## Town of Lunenburg Council Meeting

**MEMORANDUM**

**RE: BROOK STREET DRAINAGE IMPROVEMENTS**

Drawing showing CSK01 work:

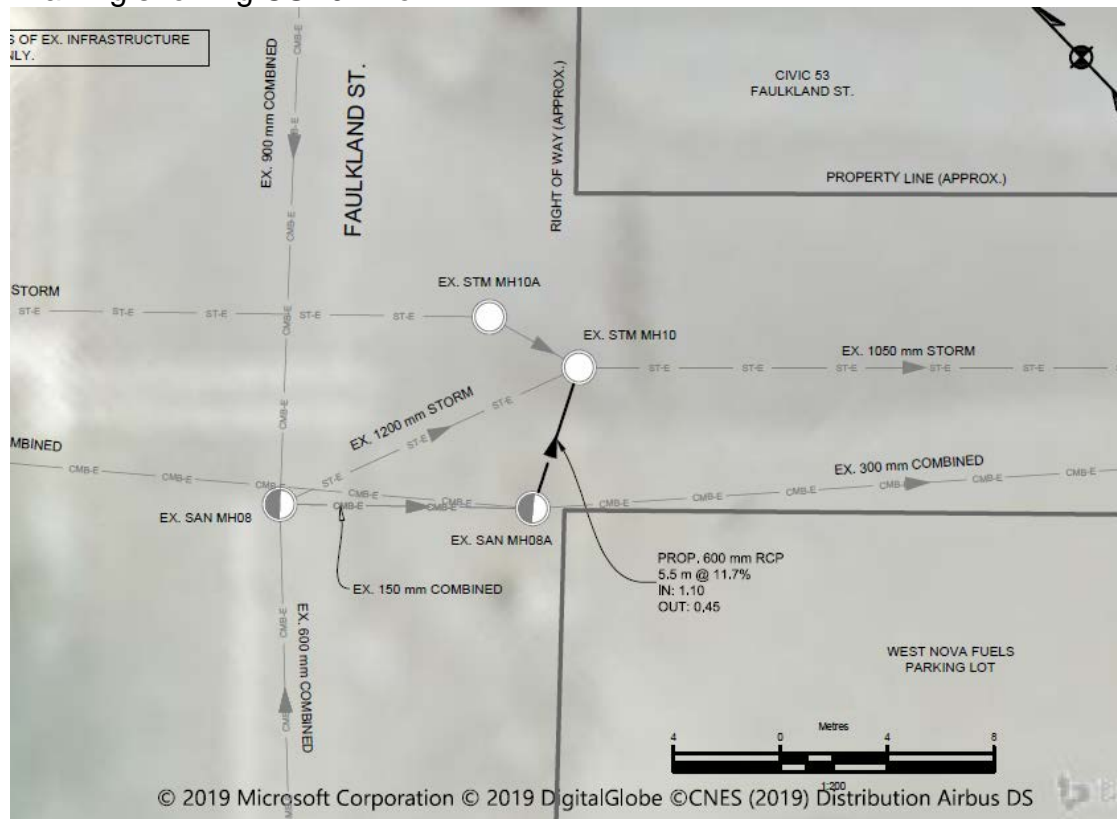
- remove CSK01 work which will now be complete by the PW crew and will be scheduled at a later date in August
- remove the CSK05 work which will have to be differed
- remove the supply of two long lead items, which PW and Procurement have gone ahead and ordered directly from the supplier eventually to be turned over to the contractor
- received a revised submission from the low bidder based on the revised scope. The draft contract has been adjusted to reflect the revised scope and price.

Drawing Showing CSK02 revised work:

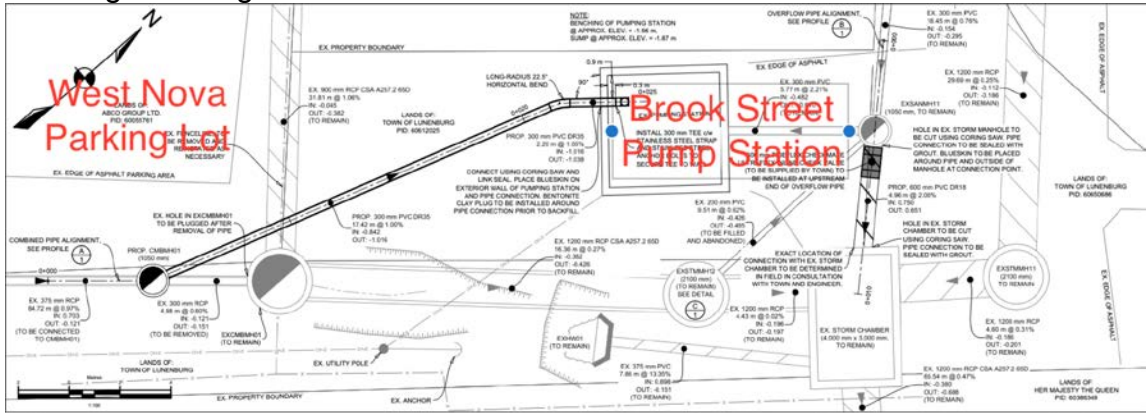
- to include only the critical functional elements from the CSK02 work thereby leaving out some of the elements which are not functional elements but more condition renewal elements such as the re-building of one large catch basin
